AIRWORTHINESS DIRECTIVE

SUBJECT: Inspection of trim spring system

BULLETIN No BR-033/88 "JANTAR St.-2"

Ref : Inspection for eventual collision of the trimming-spring and cockpit floor and consequent correction of the trimming-spring arm length /concerns the SZD-48 and SZD-48-1 glider types/.

Fig. 1.

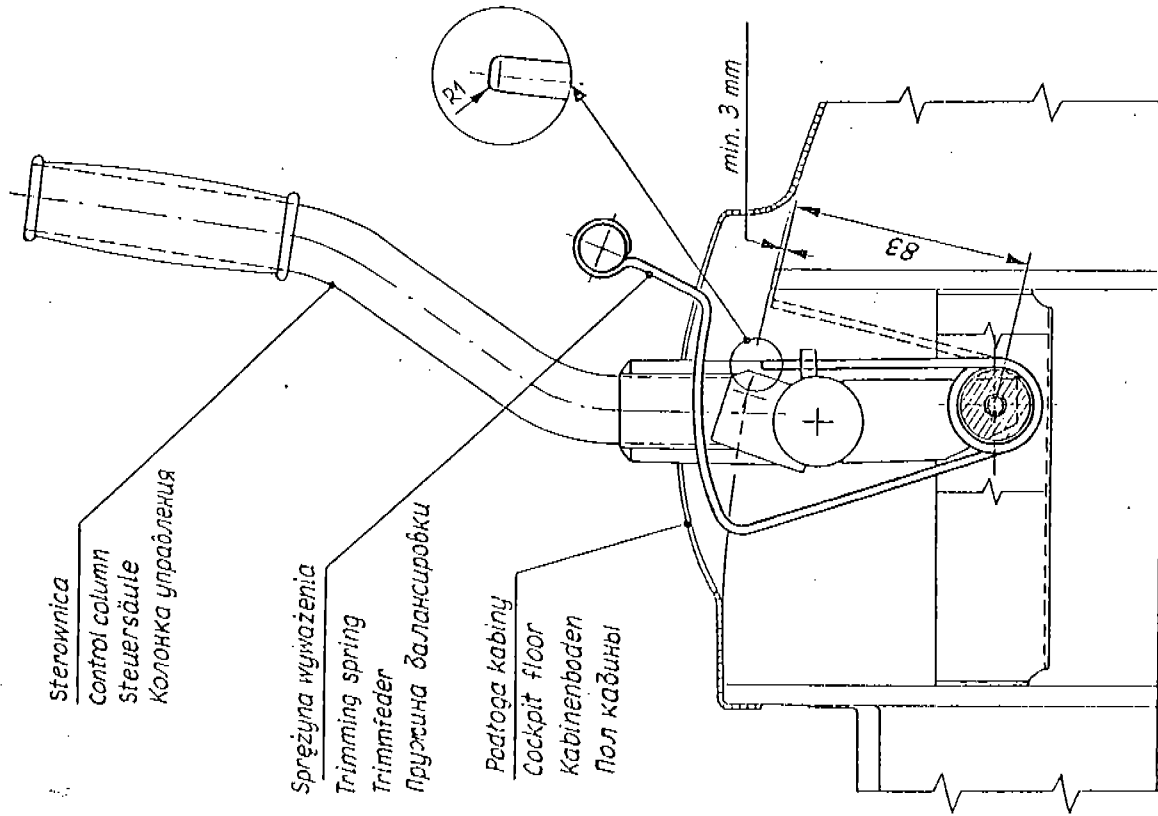
4.3. Measure the disassembled spring and check the length of the arm fitted in the "eye" on the control column body /see Fig.1/. The arm length should be 83 mm. If the arm is longer it should be grinded for the correct dimension and the end rounded as shown on the sketch. If the dimension is correct the end should be rounded only.

4.4. Reassemble the total unit. Move the arm of the trimming-spring into its front limit position and pull the control stick "back" and check the distance of spring end to floor /minimum clearance should range 3 mm/ through the opening near the stick.
